Title: Power

Project: Arm.PjPcb

Rev: 2 Reviewer: Lance Bantoto

Engineer: Kyle Hong

Mounting Holes

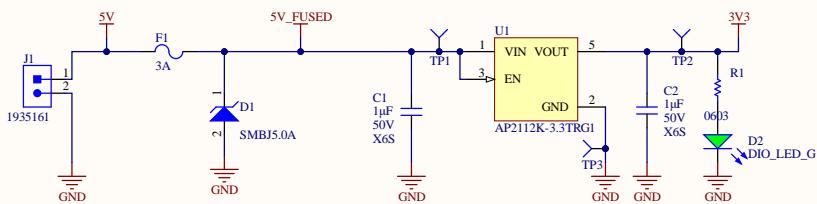
Need to make new mounting hole part depending on Andrew's fastener choice

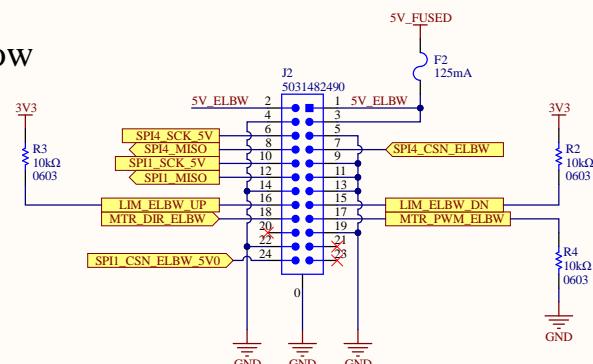
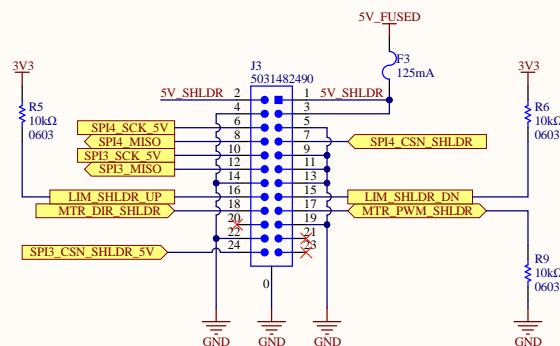
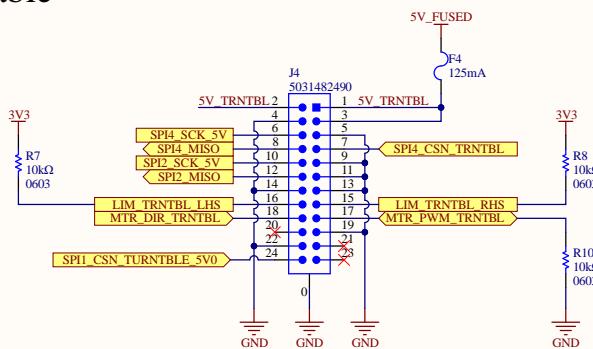
Add eFuse for Rev 3
